APPLICATION FOR PERMISSION
UNDER SECTION 16 OF
THE TOWN PLANNING ORDINANCE
(CAP.131)

**Application for Permission under Section 16 of the Town Planning Ordinance for
Proposed Residential and Commercial Development atop Siu Ho Wan Depot
Proposed Layout Plan Submission – Application No. A/I-SHW/1**

**Section 16 Planning Application (No. A/I-SHW/1) for
Proposed Residential and Commercial Development atop Siu Ho Wan Depot
Response-to-comments received from Government Bureaux / Departments**

Figure 2.2

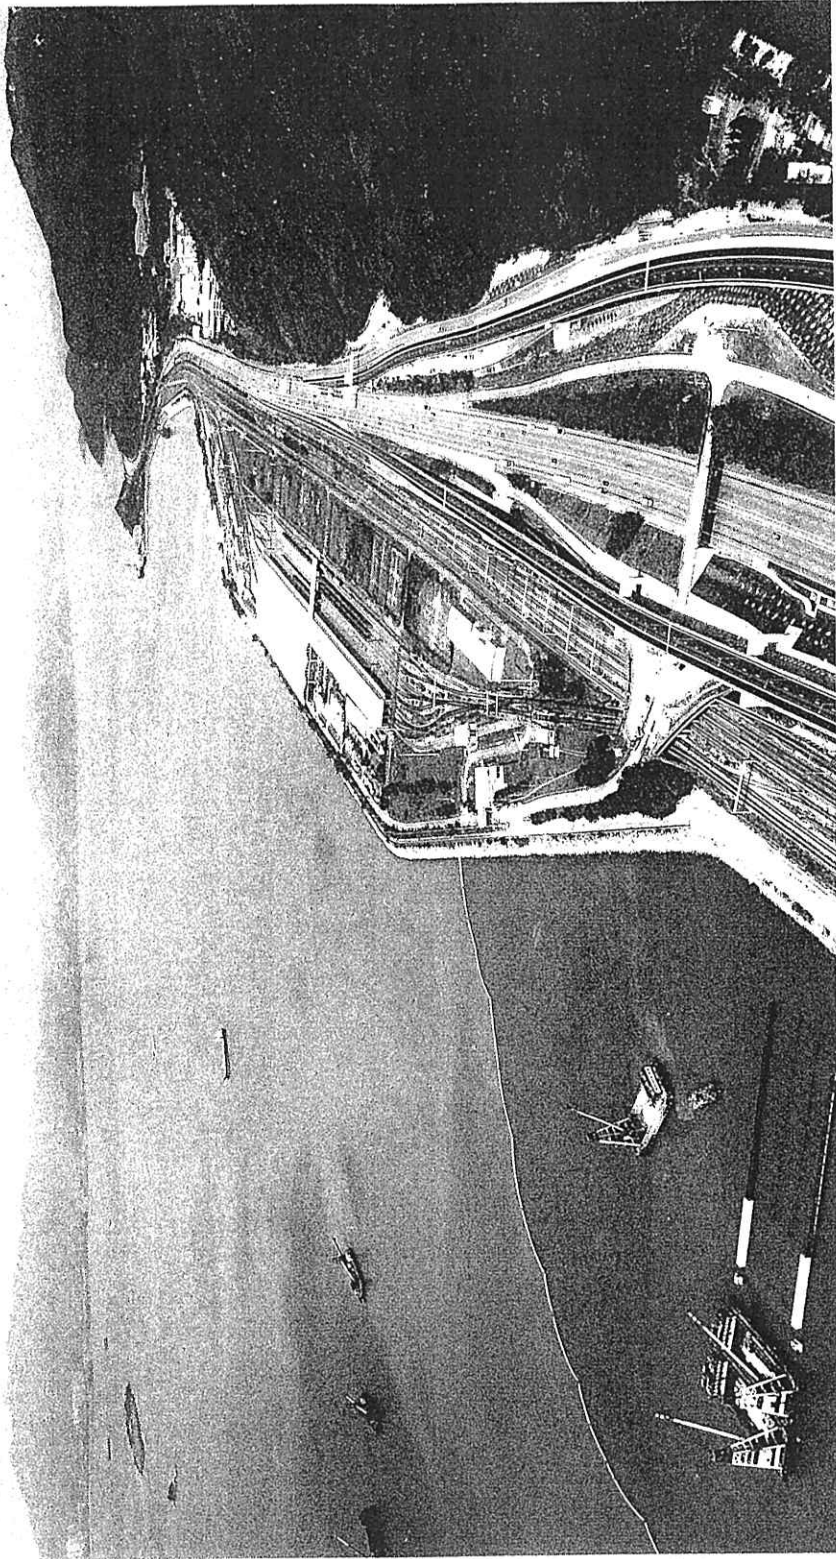
18.	It is noted that the "columbarium at Siu Ho Wan" is indicated in Figure 2.2. Sham Shui Kok Drive would be re-aligned to facilitate the development of proposed columbarium. Moreover, during Ching Ming/ Chung Yeung festival periods, the Sham Shui Kok Drive is proposed to be closed temporarily for implementation of temporary traffic arrangement. Only specially arranged-buses (for grave sweepers to/from Sunny Bay Station/ Tung Chung), vehicles to/from North Lantau Refuse Transfer Station and vehicles with permit would be allowed to enter Sham Shui Kok Drive. As such, the applicant shall take into account the cumulative impact of the proposed columbarium development in the Traffic and Transport Impact Assessment. There is doubt whether the traffic to/from North Lantau Refuse Transfer Station and the proposed columbarium has been included in the traffic forecast at Road Links ID70-73 (i.e. Sham Shui Kok Drive).	Please be clarified that the Road P1 (Tai Ho – Sunny Bay Section), is anticipated to be available by 2030 according to LegCo Paper No. PWSC(2020-21)24. For the Traffic and Transport Impact Assessment, the Proposed Road P1 (Tai Ho – Sunny Bay Section) is assumed to be in place by year 2031. The eastern access of the Proposed Development will be connected to the Proposed Road P1 (Tai Ho – Sunny Bay Section) as indicated on the Layout Plan in Annex 2.1 of the Planning Statement. As such, it is considered the impact by the temporary traffic arrangement by the proposed columbarium during Ching Ming / Chung Yeung Festival is minimal. MTRC will liaise with Government departments in regards to the interface issues at Sham Shui Kok Drive.

Figure LS4.1

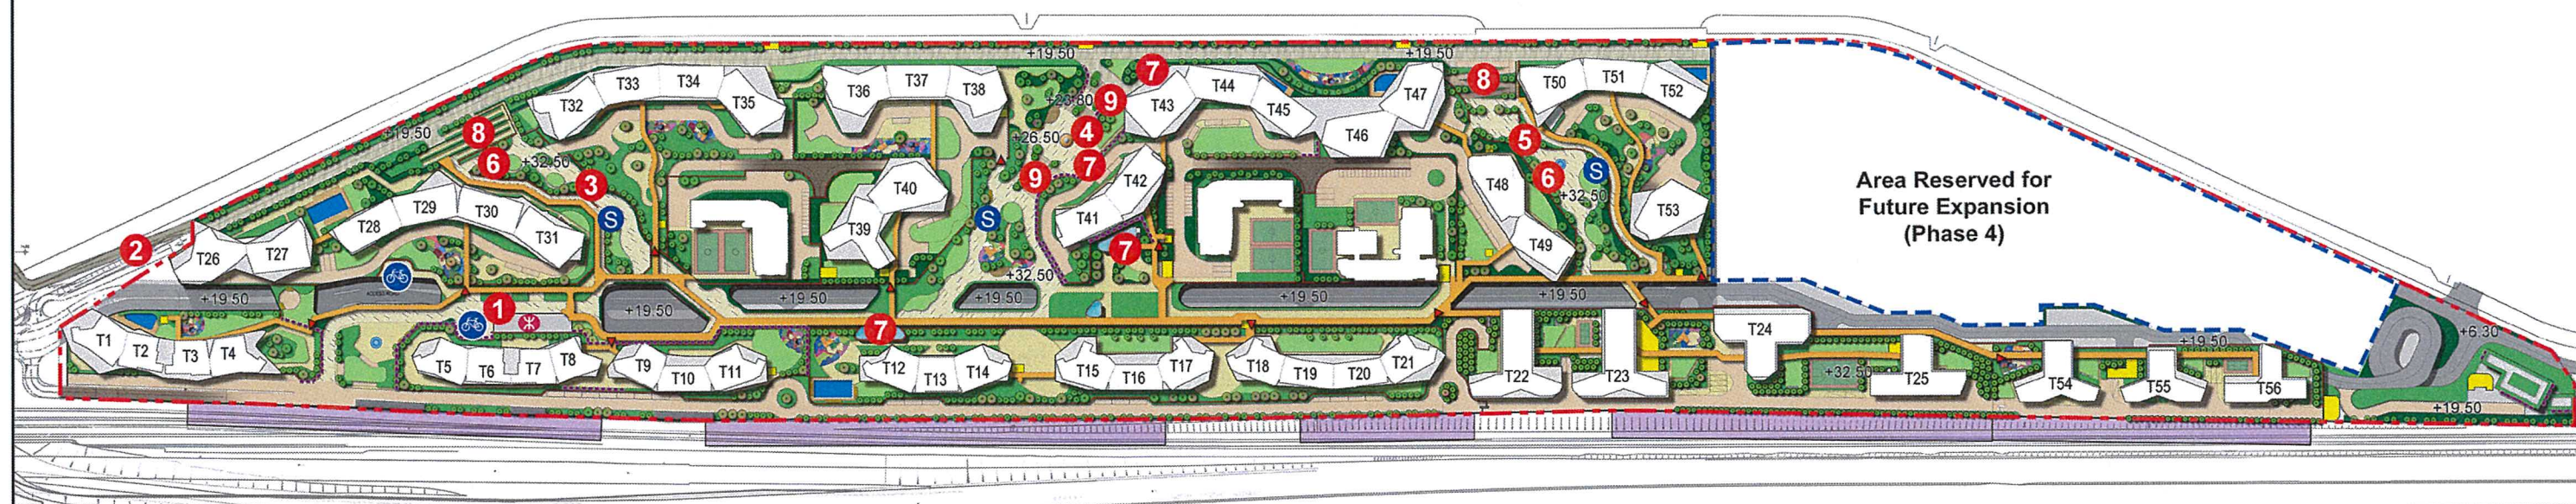
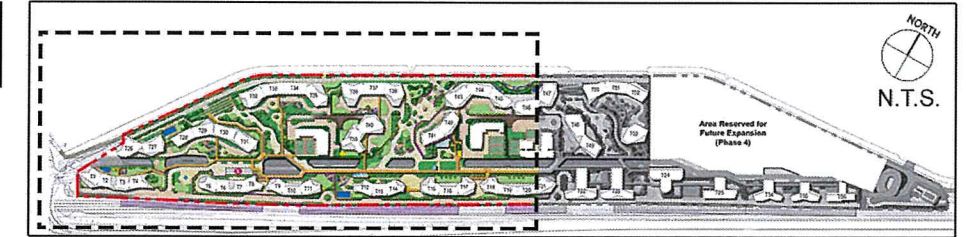
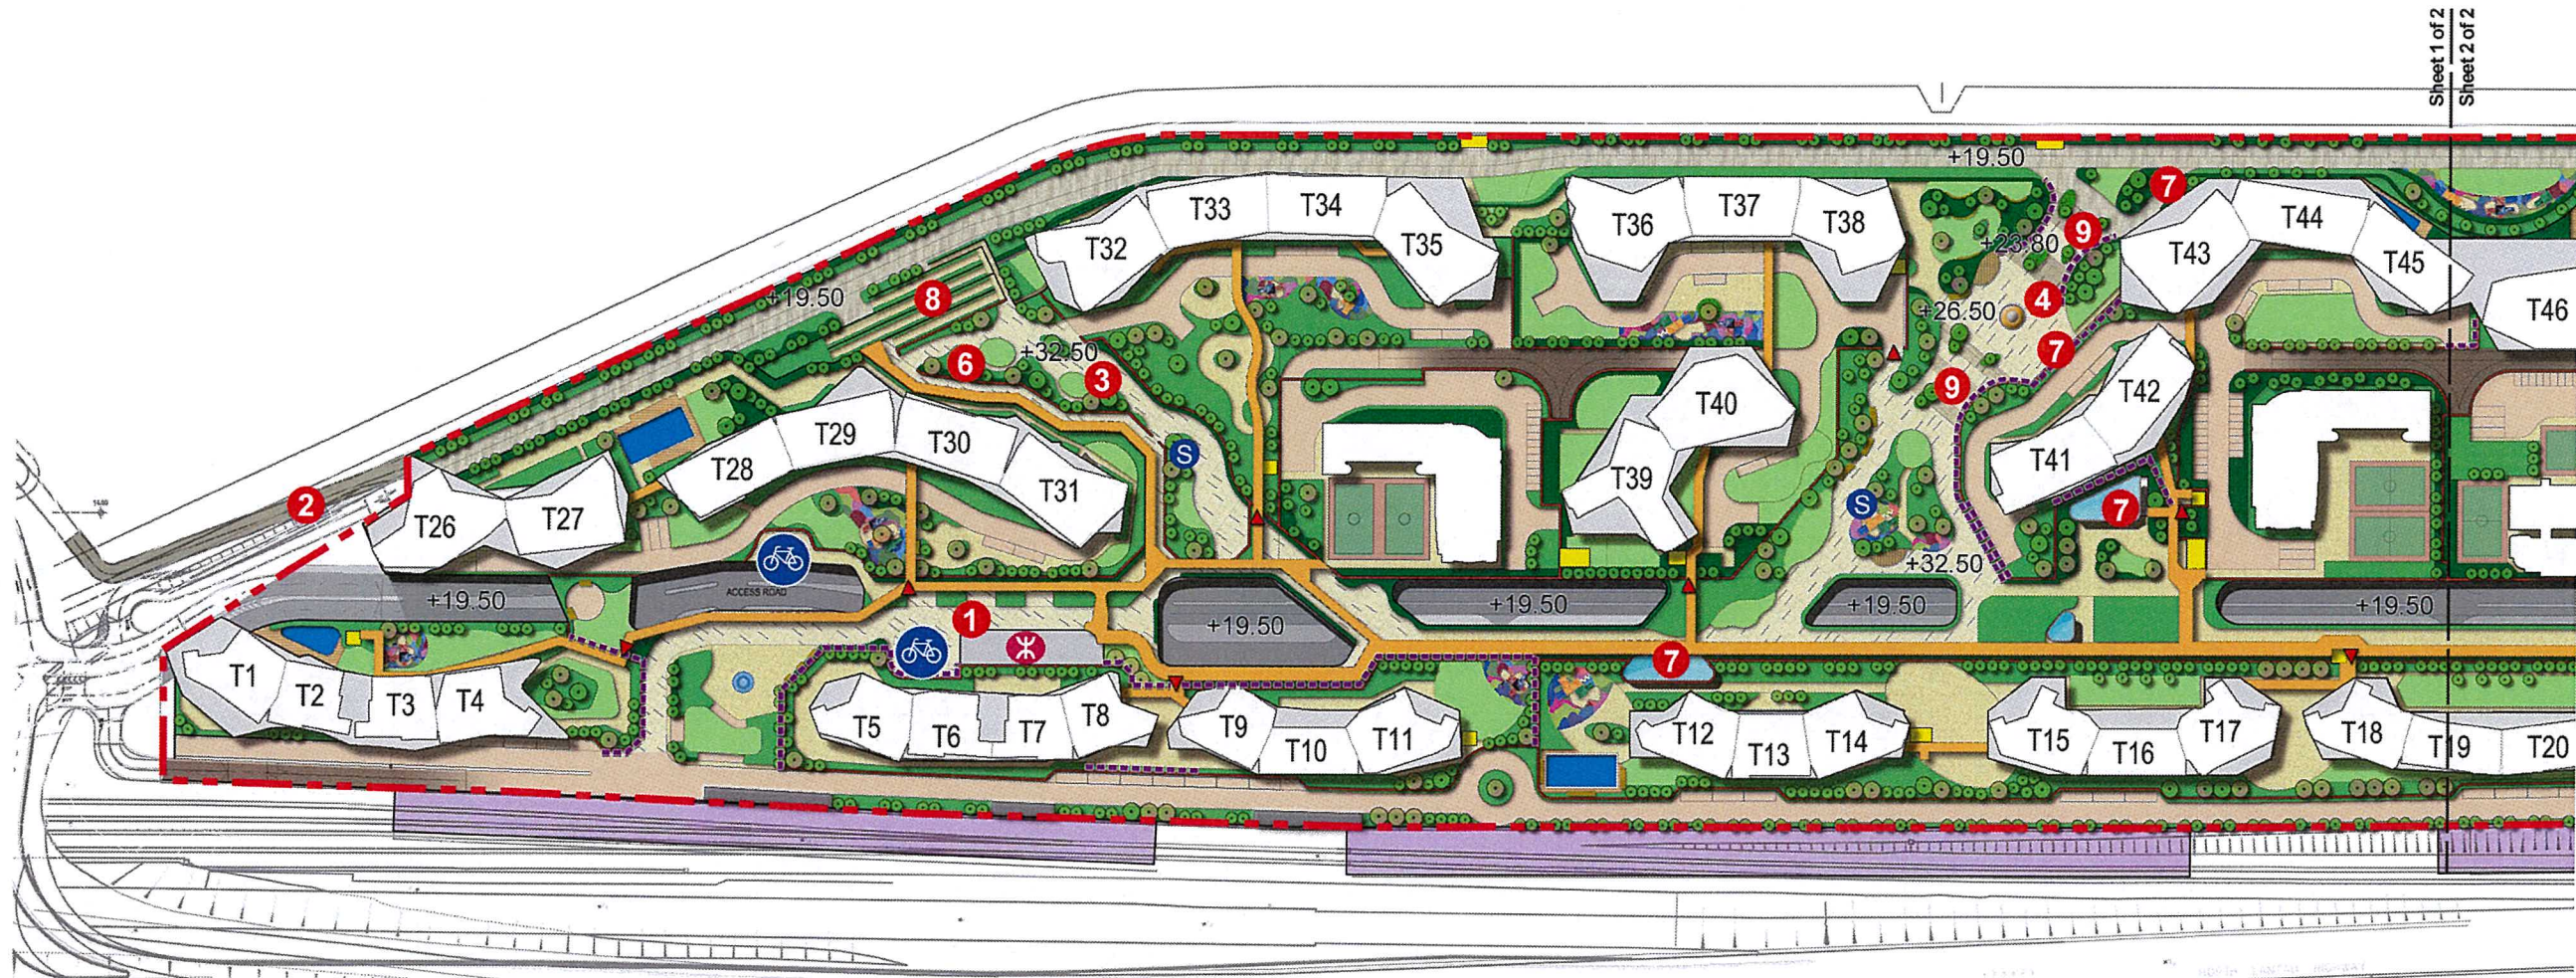
24.	<p>However, the Applicant should clarify in the proposed layout plan submission on the followings:-</p> <p>a) Figure LS4.1 to 4.1.6</p> <p>- Please provide the no. of proposed new tree planting in phase 1-3 in the legend.</p> <p>- The proposed vertical greening is not legible from the plan.</p>	<p>Please refer to Attachment 1 for the updated Figure LS4.1 to 4.1.6 with the number of proposed new tree planting (about 1,200 trees) added in the legend and the legibility of the vertical greening enhanced.</p>

Landscape Section Showing the Green Spine at +32.5mPD and the Main Driveway at +19.5mPD

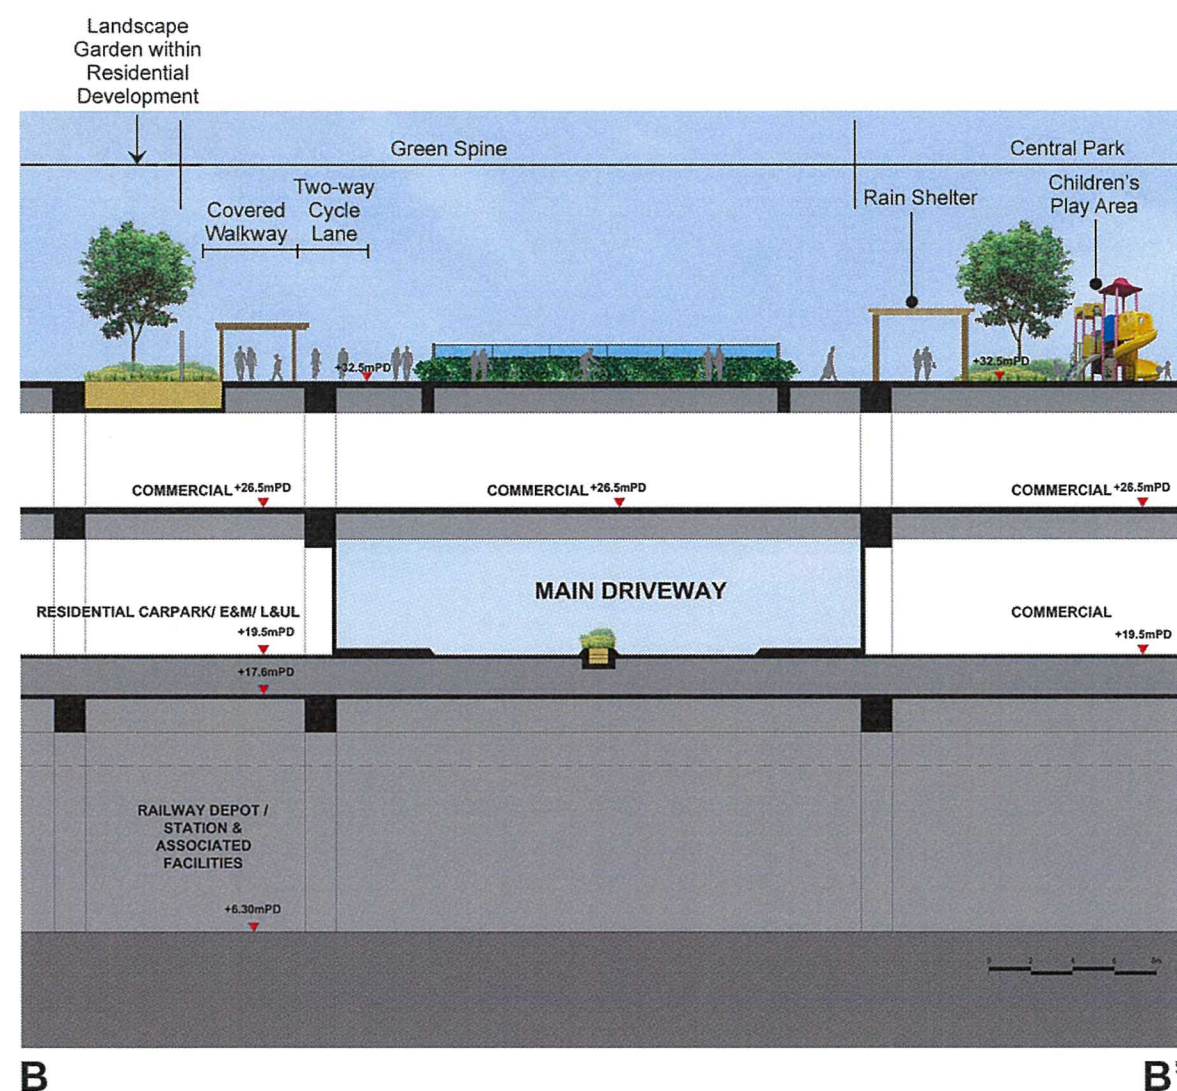
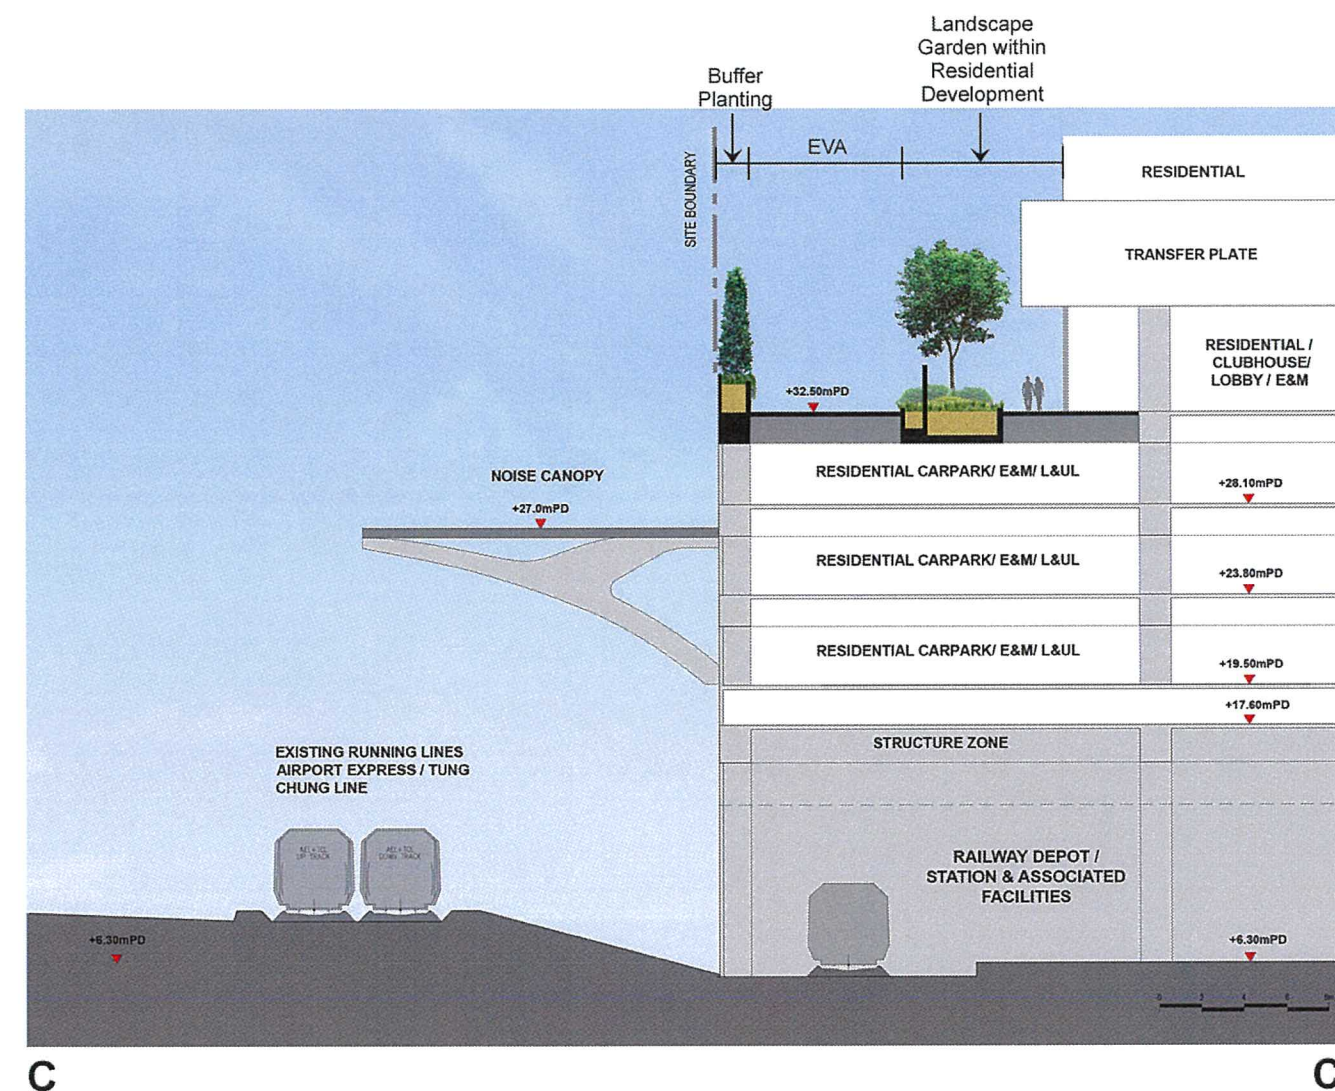
25.	<p>b) Figure LS4.2b - Referring to landscape section B, the drawing of green spine is not in scale.</p>	<p>Please refer to Attachment 2 for the updated Figure LS4.2b.</p>
